**December 8, 2020
7:00 PM
Planning Board Agenda**

Public hearing on applications for Special Use Permit and Site Plan Approval, accessory apartment, 179 Union Street, submitted by John Kittredge & Amanda Gisonni

[Engineer Review Letter.pdf](#)

[Planner Review Letter.pdf](#)

4 ACCESSIBILITY PARKING DETAILS
1" = 1'-0"

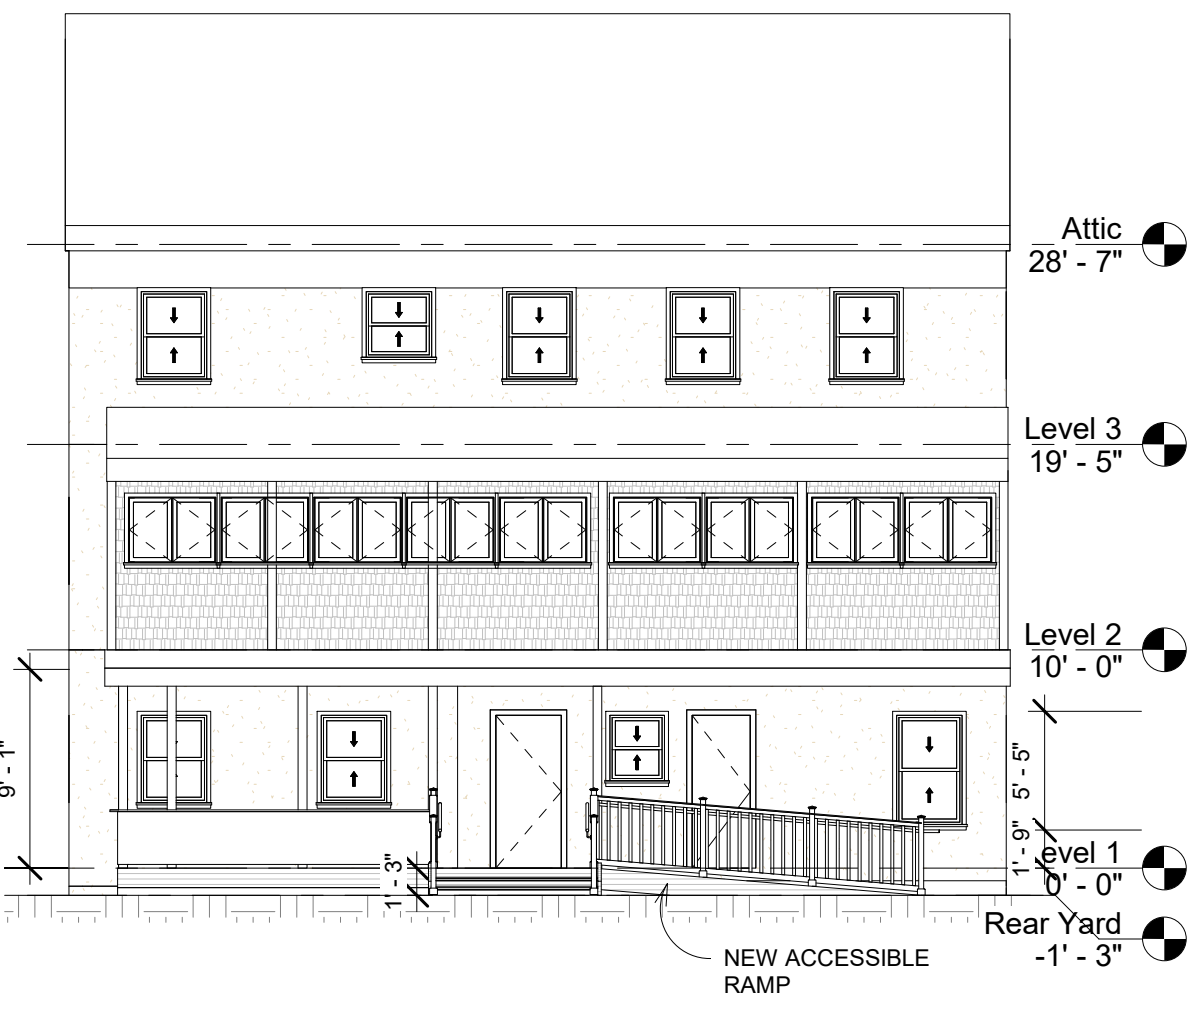
11. 'The detail for the accessible parking stall and access aisle shown on Sheet 3 of the plan set should be updated to reflect the required 8-foot wide access aisle, along with noting the required color for the striping. This detail should be further updated to reflect the signage required for the accessible parking stall and access aisle, along with providing details for the proposed signage.'

- f. The drawing set has been updated to include the landscaping plan and plant schedule, see drawing A-002.00.*
4. 'For Sheet A-101:
- a. The ADA parking detail should show an 8-foot striped aisle and the ADA space may be 8-feet wide.

The drawing set has been updated to include a 8-foot access aisle and the required signage according to Section 1111 of the Building Code. The Site Plan on Sheet A-101.00 includes annotations for the location of the required signage and Sheet G-000.00 contains further details on the required signage, as well as information on the required locations, dimensions, and marking colors for accessible parking spaces.

The Plan drawing on Sheet A-101.00 has been updated to reflect the required 8-foot wide access aisle. In addition, further details on the required signage, locations, dimensions, and marking colors for accessible parking spaces has been added to Sheet G-000.00.

a. The Plan drawing on Sheet A-101.00 has been updated to reflect the required 8-foot wide access aisle.

③ Site Plan
1" = 20'-0"

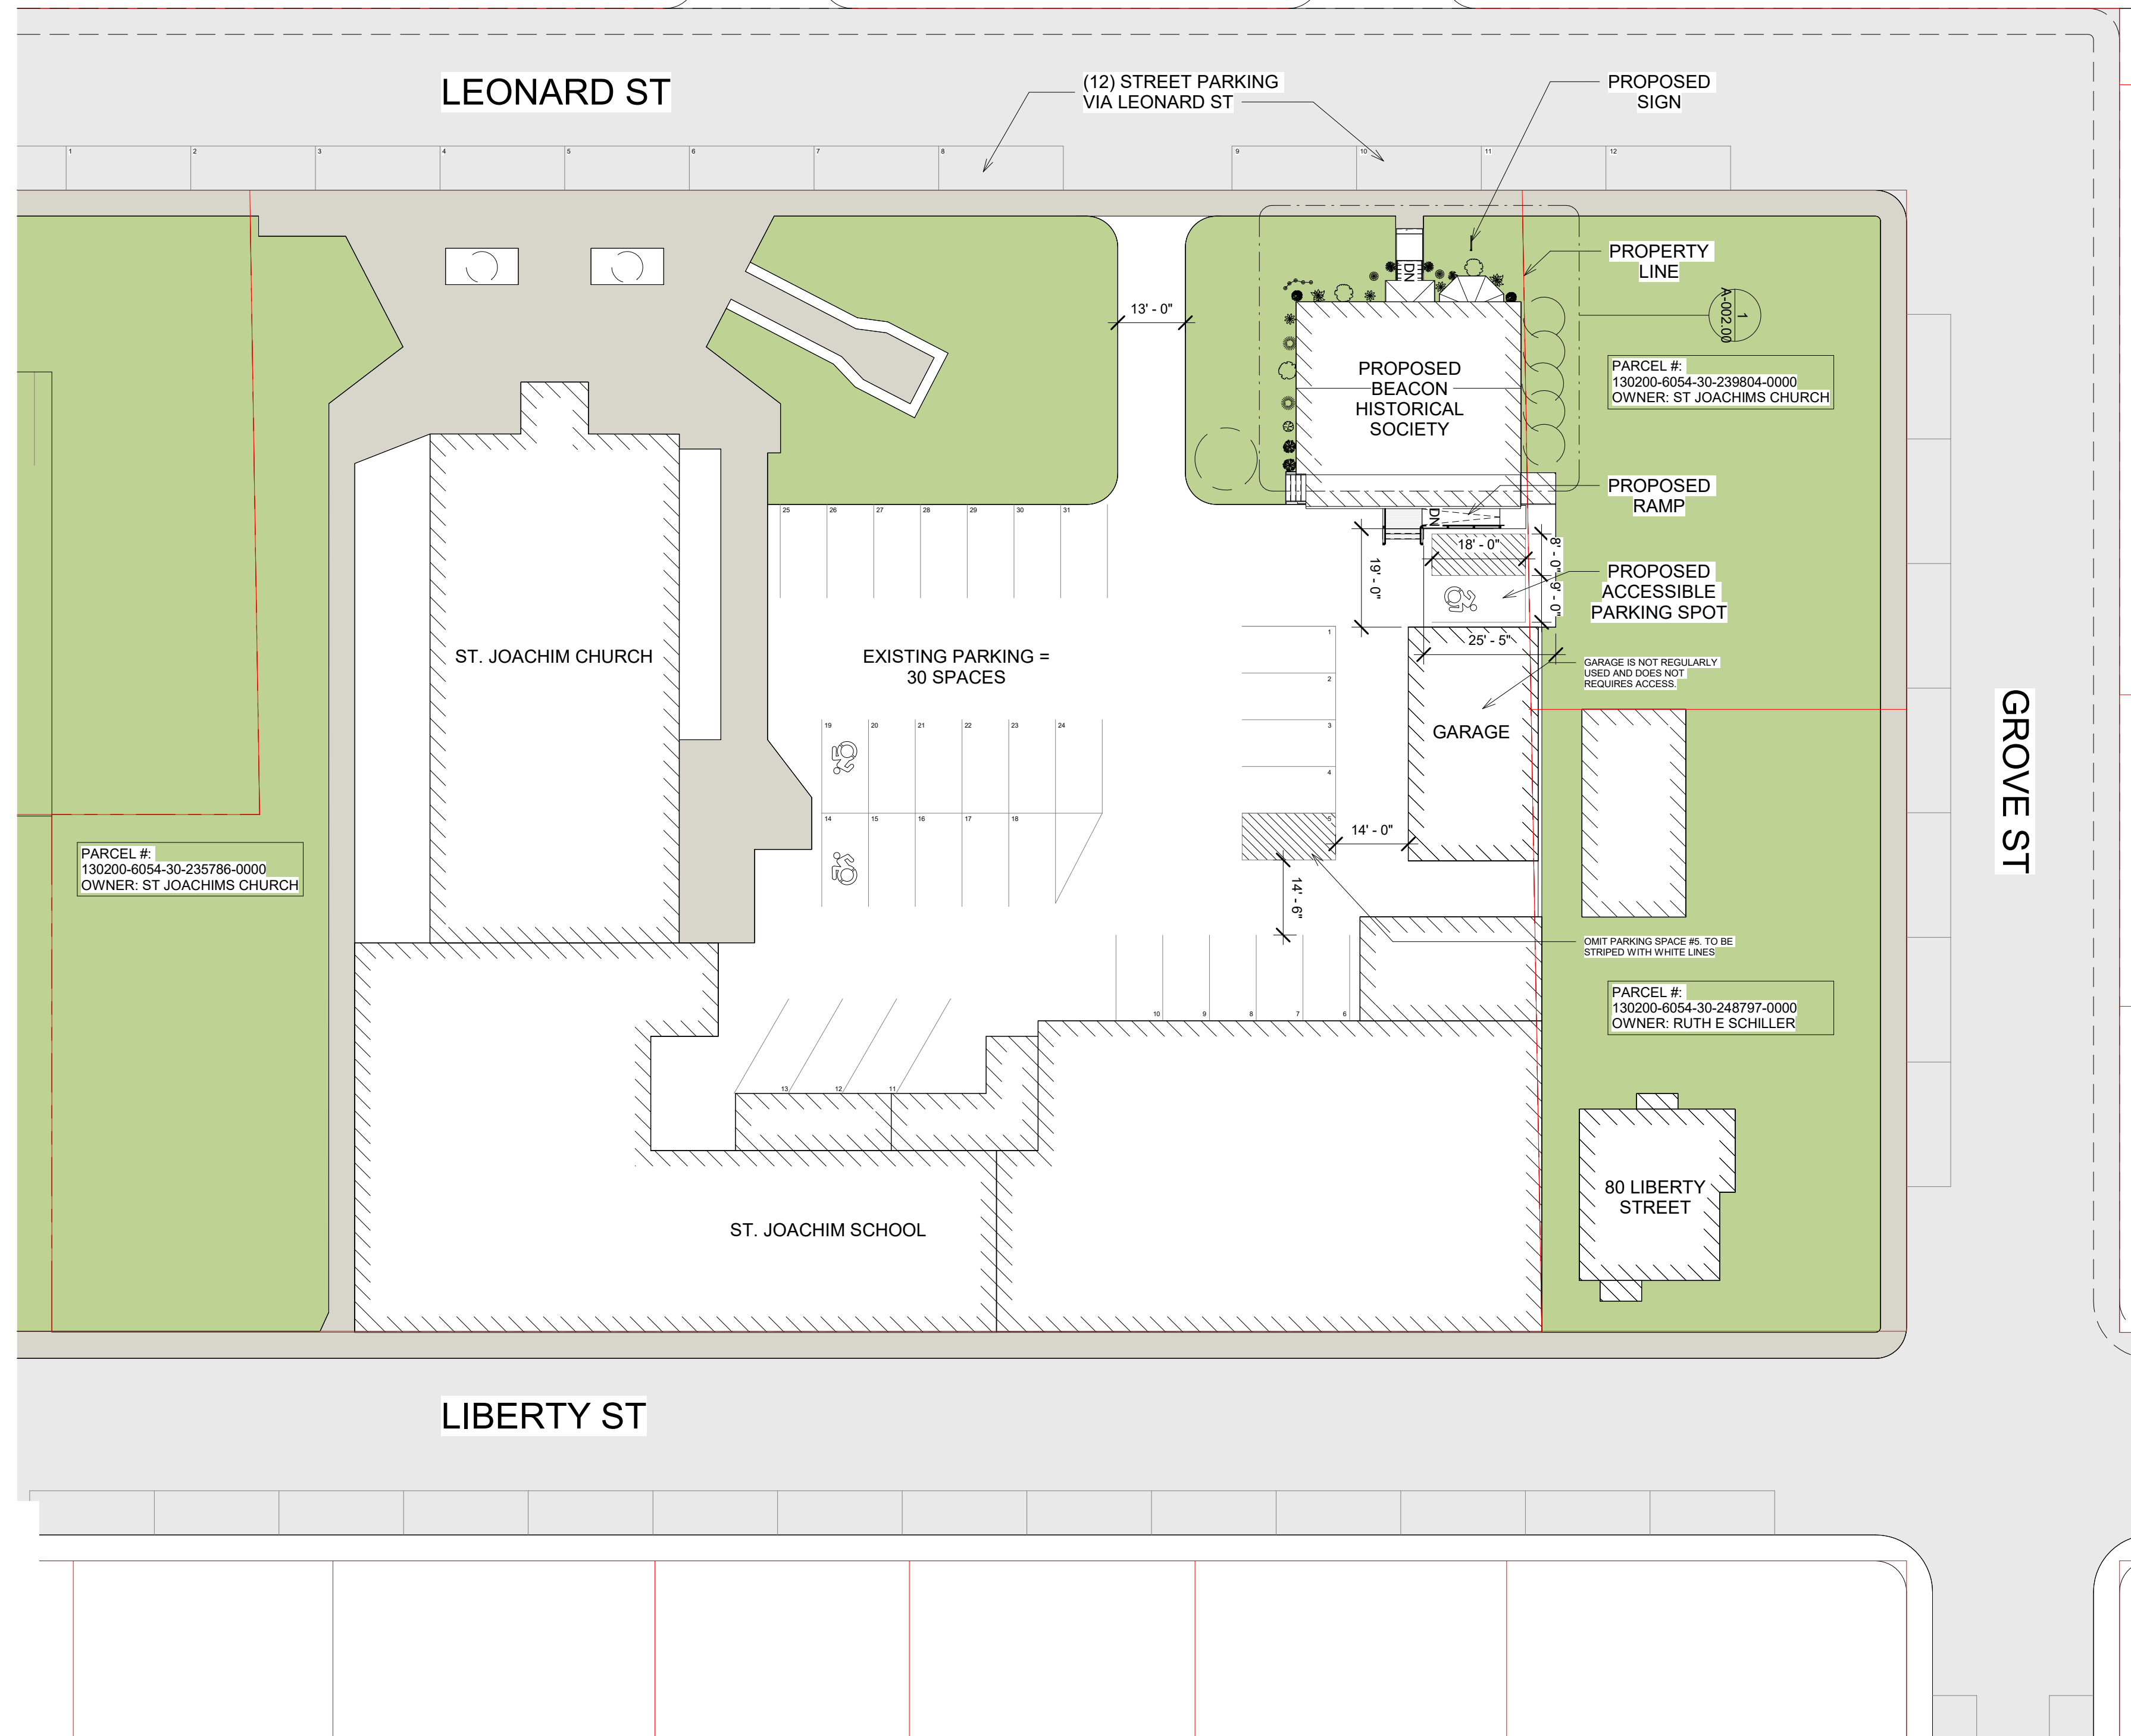
3. 'For Sheet A-001, Site Plan:
- a. A scale should be provided the Site Plan.
 - b. The ADA striped aisle should be 8 feet wide by state requirements.
 - c. The parking spaces designated for Historical Society use should be designated on the Site Plan.

The Site Plan on Sheet A-001.00 has been updated with a note to omit parking stall 6.

Based on planning board discussion, a survey was not required. The owners and parcel numbers of the adjacent properties were annotated on the Site Plan on Sheet A-001.00.

- b. The access aisle has been updated to reflect the 8-foot wide requirements.*
 - c. The designated parking spaces for the Beacon Historical Society have been annotated with an asterisk on the Site Plan drawing and a sheet note has been added to Sheet A-001.00.*

- d. Understood that the garage is not regularly accessed and is used for storage.*
 - e. The owners and parcel numbers of the adjacent properties were annotated on the Site Plan on Sheet A-001.00.*
